**RE: 20/P/1847 65 HOUSES ON LAND WEST OF RODNEY ROAD**

I have been asked to review recent plans submitted by Stantec in relation to the design of the access. The two plans are 46669/5501/009/B and 46669/5501/001/C.

LAND AT RODNEY ROAD, BACKWELL

REVIEW OF TAYLOR WIMPEY PROPOSED ACCESS

FIGURE 1

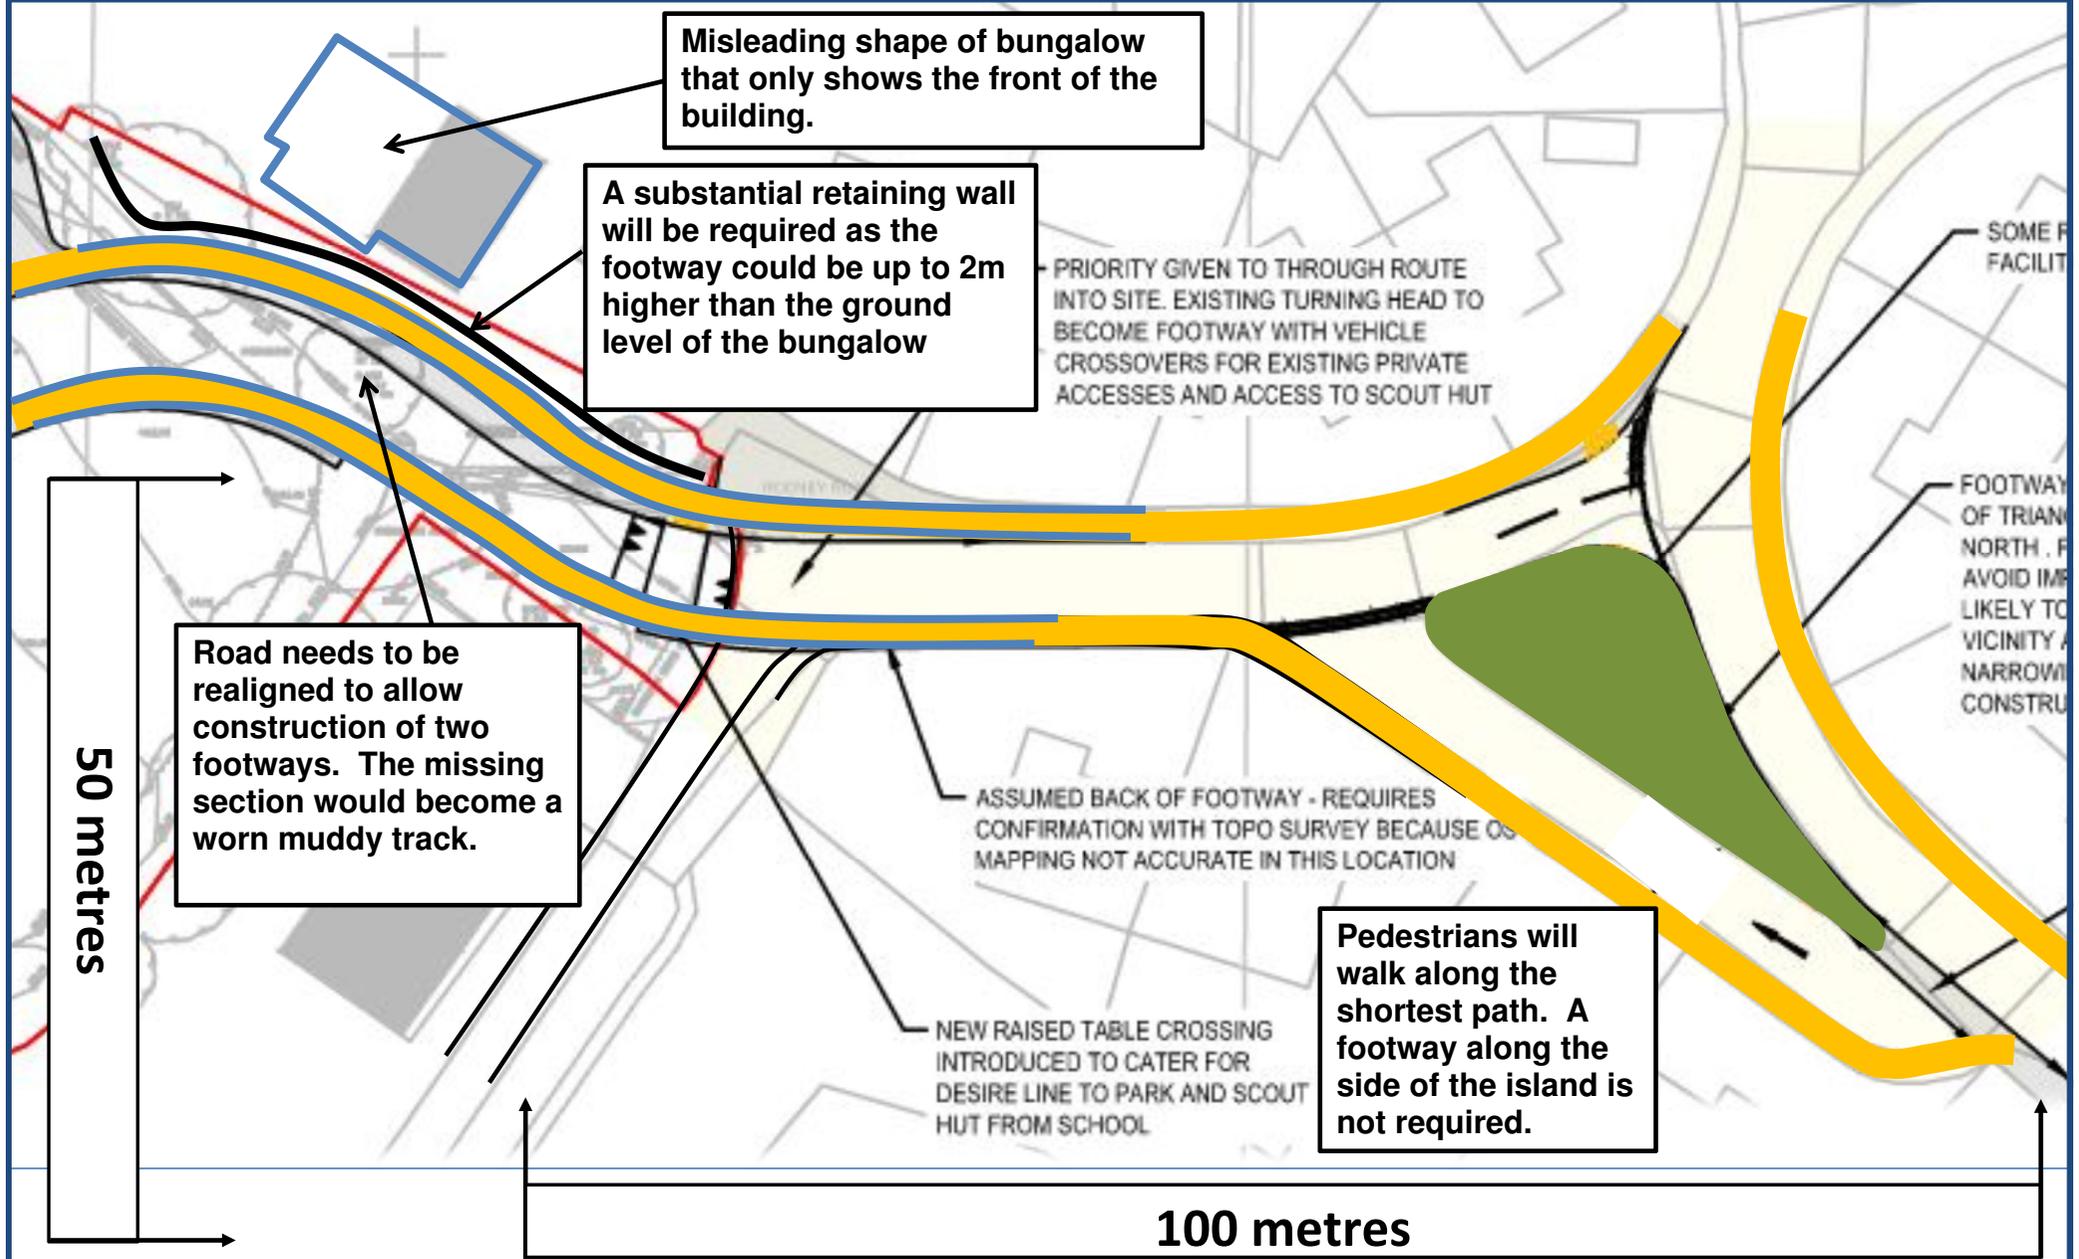
I have prepared a plan (**Figure 1**) which identifies the main issues that need to be addressed. These are briefly summarised below:

- 1 Due to the difference in ground level between the entry point to the site and the first 60 metres of the access road it is clear that full cross sections and a long section should be provided for the first 100 metres entering the site. This will allow account to be taken of the gradient that will be necessary to get back to the site ground levels that are considerably higher than the entry point. It will also show how the road will be retained close to the bungalow on the north side of the entry. As shown on **Figure 1** the proposed road could be up to 2m higher than the ground level adjacent to the bungalow and a possible retaining wall will be very close to the bungalow walls.

- 2 The latest plans show a gap in the footway on the southern side adjacent to the Scout Building. Pedestrians will undoubtedly still use the grass verge between the two sections of footway resulting in a worn muddy track. I consider that two footways are essential due to the numerous pedestrian movements that will be taking place to the new development, the adjacent school and the Scout building and other sporting uses on the Recreation Ground.

- 3 **Figure 1** shows a revised alignment (similar to the original submitted plans) that would allow construction of footways to both sides of the road. This would clearly make the bend of the road even closer to the bungalow and when combined with detailed cross sections may indicate that either the bungalow would need to be demolished or that an access road can only be built with one footway.

- 4 A footway is shown along the north side of the grass island and is unlikely to be used by any residents of the new development. Pedestrians will always choose the shortest path which is shown in yellow on **Figure 1** and uses the existing path along the 'service road' adjacent to houses on the south side of Rodney Road. From information provided by residents this is not a private road as suggested by Stantec.

- 5 To allow full account to be taken of all the measures suggested in the two plans it will be necessary to extend the topographical survey to include all the area shown on **Figure 1** together with much greater detail within the garden of the bungalow. A significant misleading

feature of the submitted plans is the fact that the full extent of the bungalow is not shown despite the fact that the red line boundary appears to be almost touching the boundary walls.

- 6 The change in the kerb alignment on the north side of the junction with Rodney Road is probably not required especially if the footway along the side of the island is removed from the proposals.
- 7 The plans show a possible one-way scheme which will be subject to a separate Traffic Regulation Order process. This is subject to its own consultation process and may not be agreed even if the development application is approved.
- 8 Visibility splays will be required from all proposed crossover access points and are not shown on the plans. The splay for emerging vehicles from the bungalow (to the west) may be difficult to achieve due to the acute angle and the possible retaining wall and/or boundary fence.
